Pineville
PLANNING & ZONING

Re: **Conditional Zoning Proposal for ILIM School at 505 Towne Centre (***Informational Item***)**

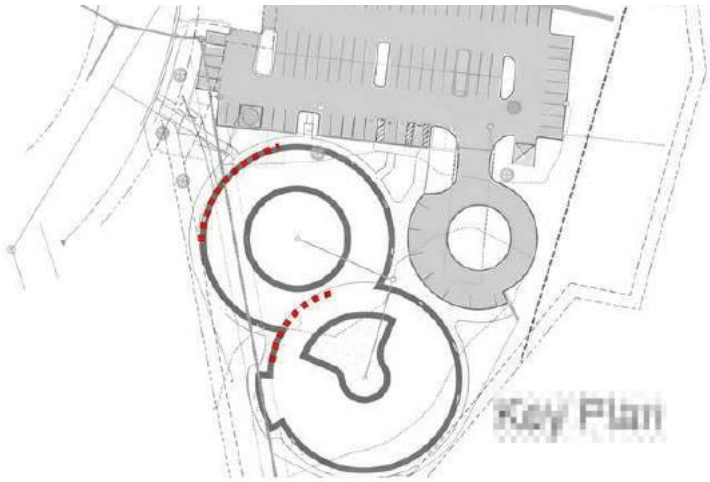
Applicant has been in review with the county and has had initial engineering and stormwater review. Recommend brick façade expanded further than just the dotted red area shown below to fully cover view from the street per the overlay requirements. Getting elevations submitted that meet the ordinances has been a challenge from the applicant. Parking lot is existing in the front yard but is not recommended because it does not meet overlay and keeps the building closer to the creek and flood issues. Towne Centre has been known to flood and become impassable to cars.
